INNER WEST

DEVELOPMENT ASSESSMENT REPORT

Application No.	DA/2020/1181
Address	86 Reynolds Street BALMAIN NSW 2041
Proposal	Demolition of existing dwelling, Torrens title subdivision into two lots, erection of two semi-detached dwelling-houses comprising three levels and associated works, including on-site parking provision.
Date of Lodgement	14 January 2021
Applicant	Raymond Panetta Architects
Owner	Guy Pahor
Number of Submissions	(14)
Value of works	\$1,000,000.00
Reason for determination at Planning Panel	Clause 4.6 variation exceeds 10% Number of submissions
Main Issues	Minimum Subdivision Lot Size
Recommendation	Approval with Conditions
Attachment A	Recommended conditions of consent
Attachment B	Plans of proposed development
Attachment C	Clause 4.6 Exception to Development Standards

Date 21.12.20 ELEVATIONS - PROPOSED
 Scale 1:100 Drawn by MM Project no 20-452 Sheet no DA11 Issue C

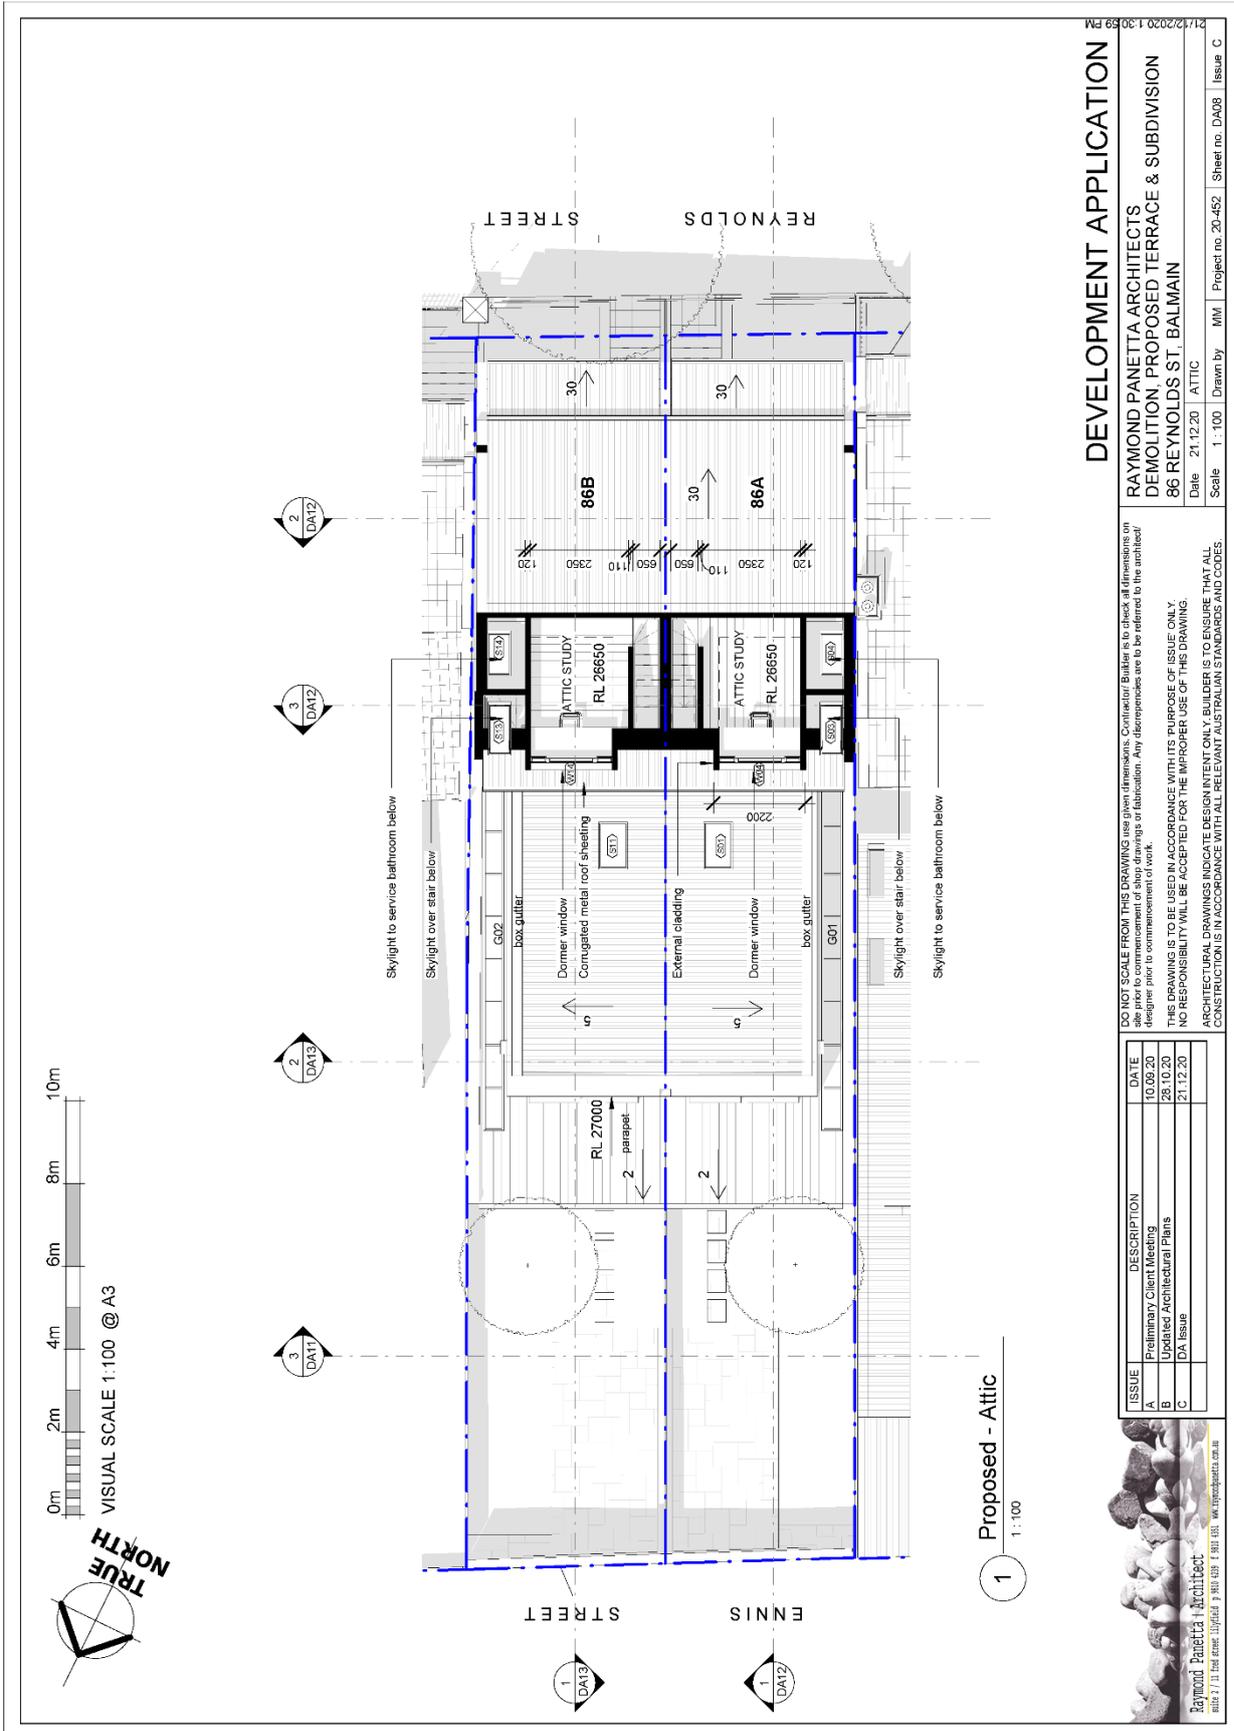
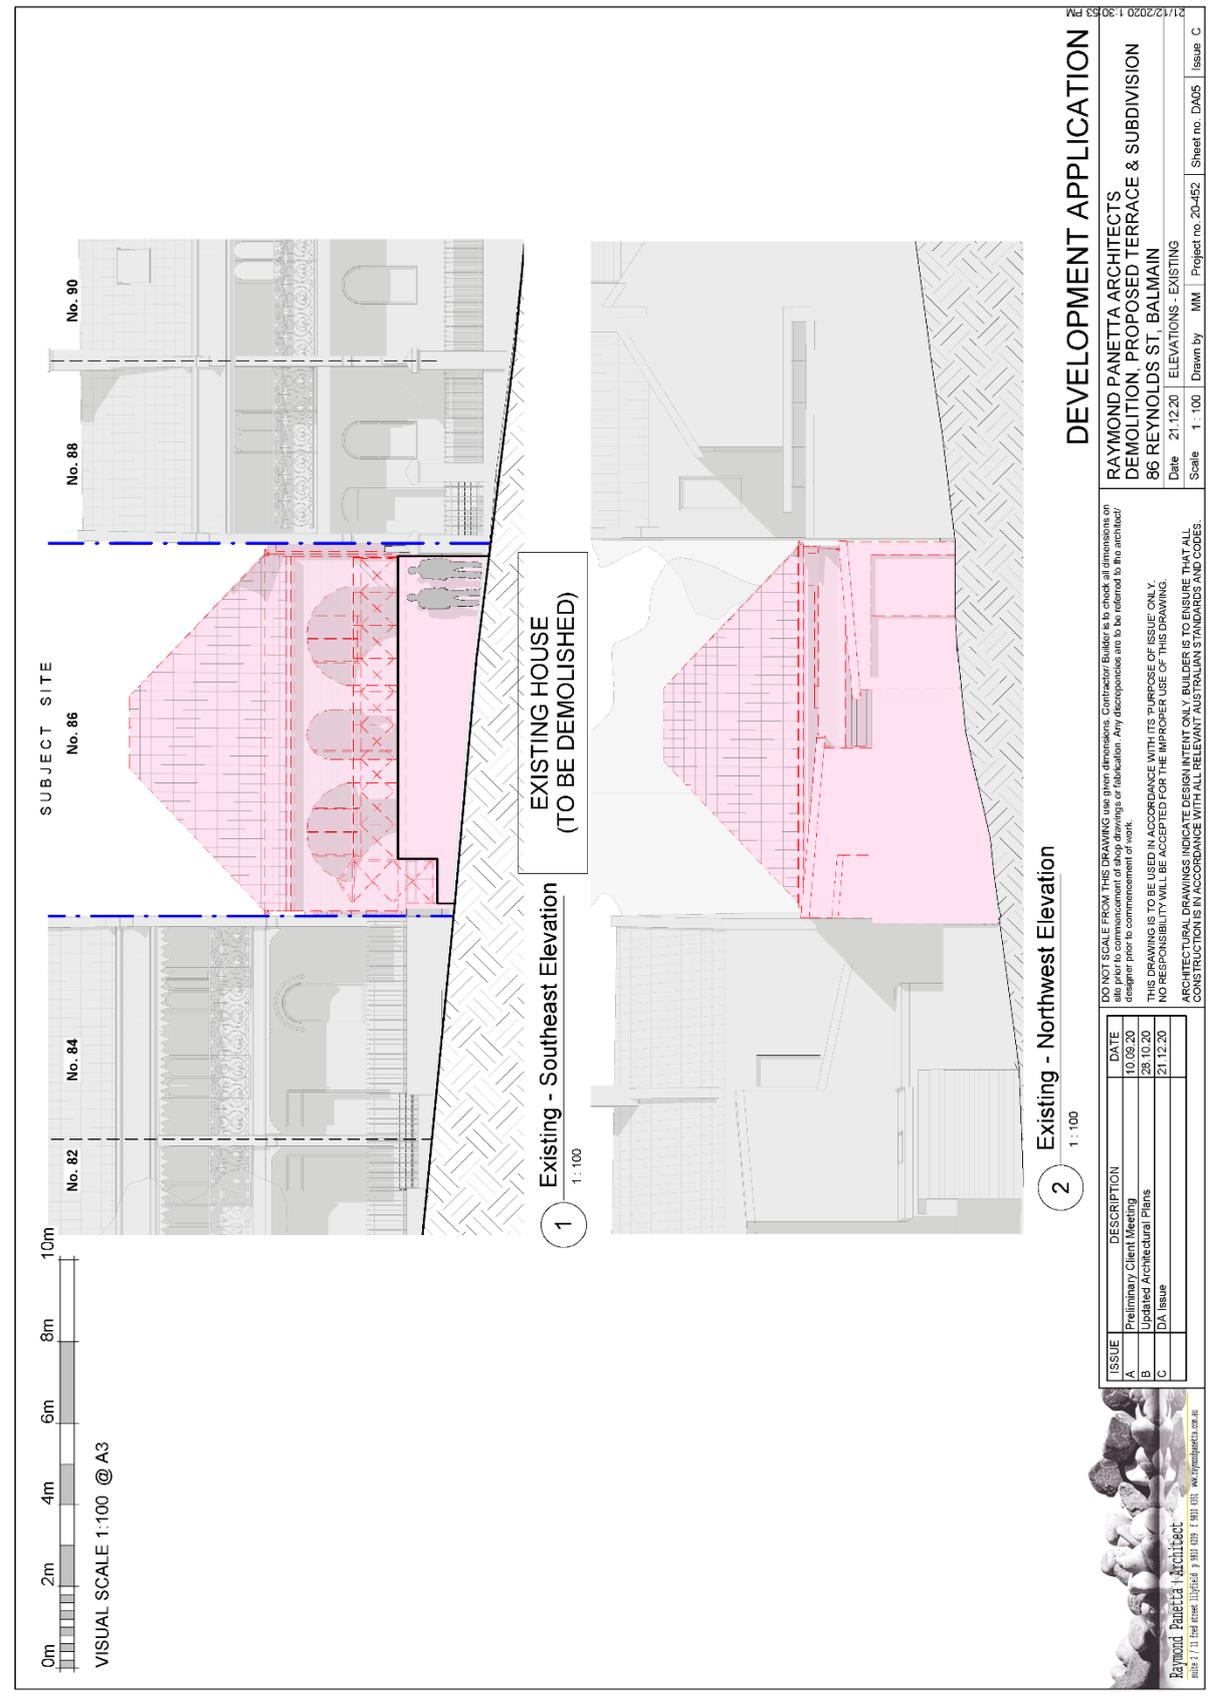
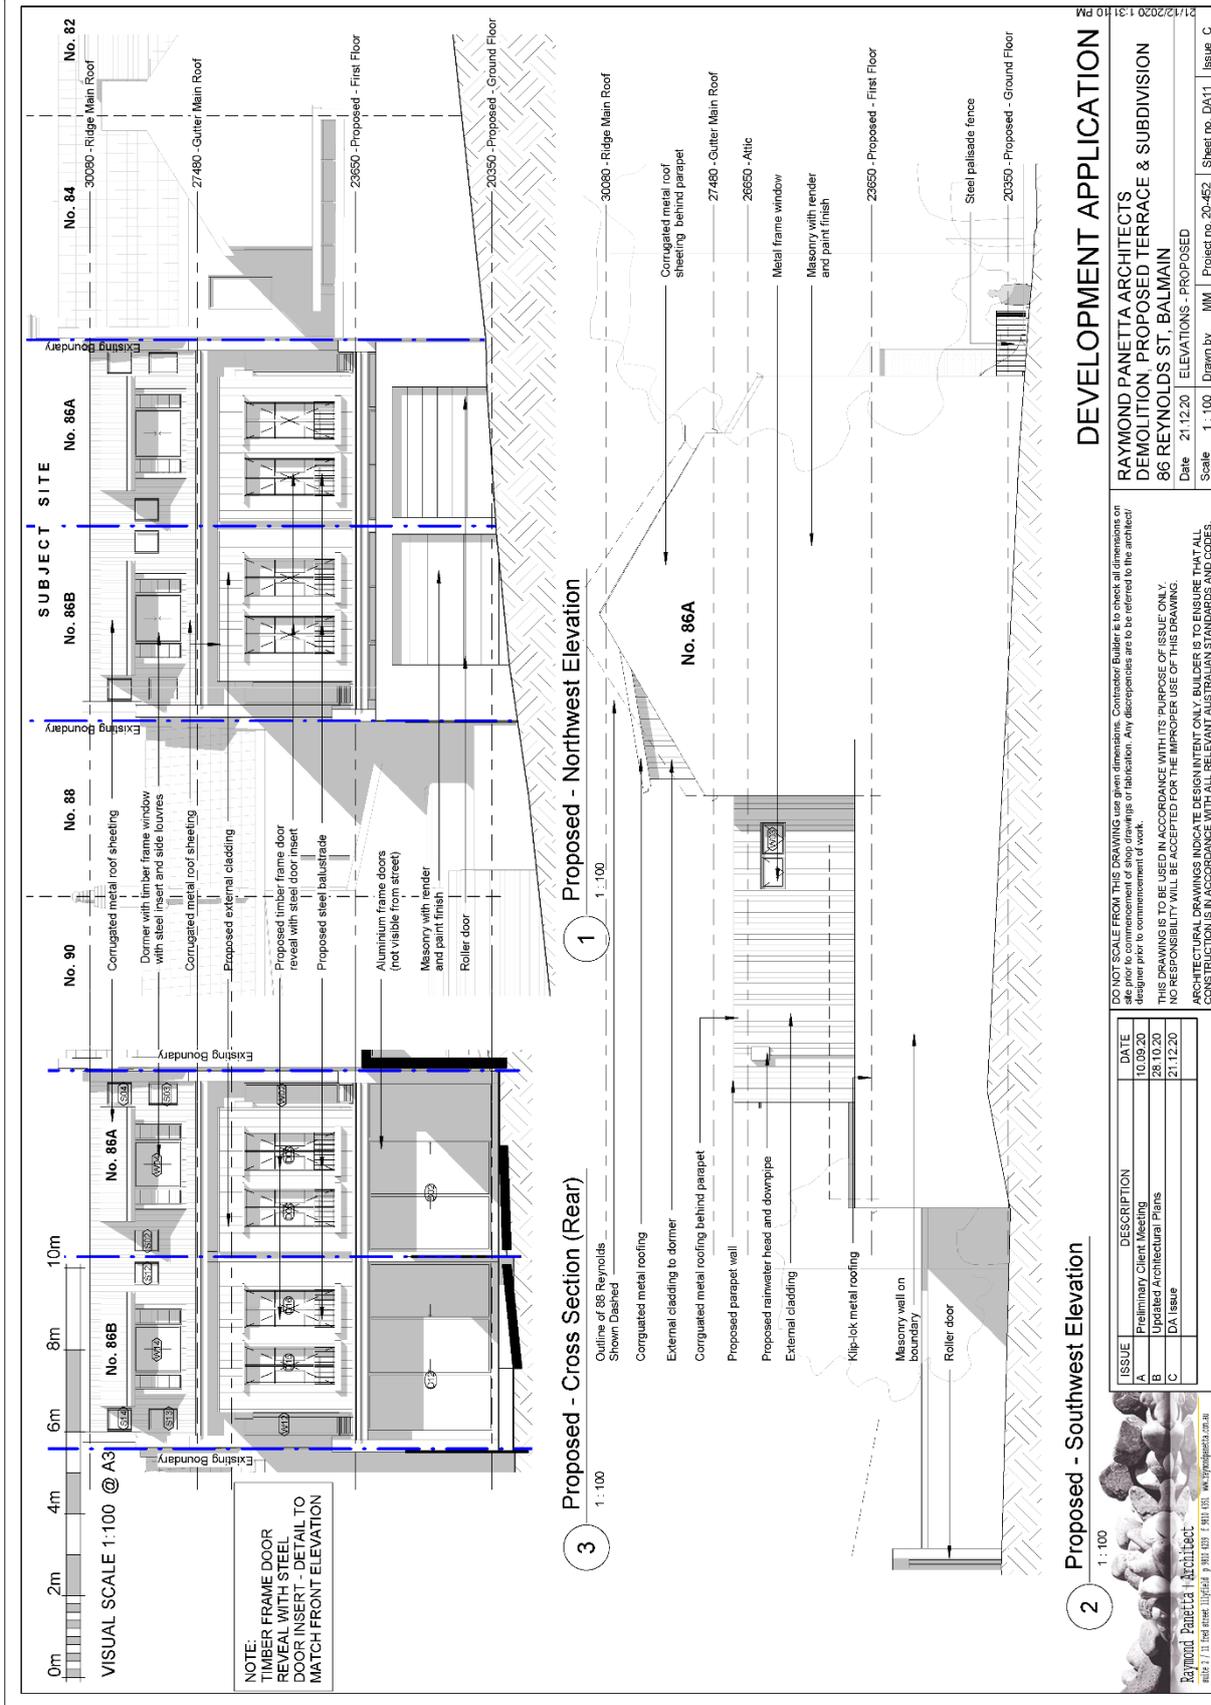
Comment: The typical door and window detail on the north east elevation shows steel frame for the doors and windows in the front façade. As stated in the pre-DA advice, openings visible from the public domain must employ traditional design (timber sash or French doors) and materials (timber frame). It is recommended the typical door and window detail for doors and windows on the north east (front) elevation and the windows on the first floors and attic levels on the north west (rear) elevation be amended from steel frame inserts to timber frame and timber inserts as a design change condition.

- a) The detail of the doors and windows on the north east (front) elevation and the windows on the first floors and attic levels on the north west (rear) elevation are to be amended from steel frame inserts to timber frame inserts.

- a. The detail of the doors and windows on the north east (front) elevation and the windows on the first floors and attic levels on the north west (rear) elevation are to be amended from steel frame inserts to timber frame inserts.
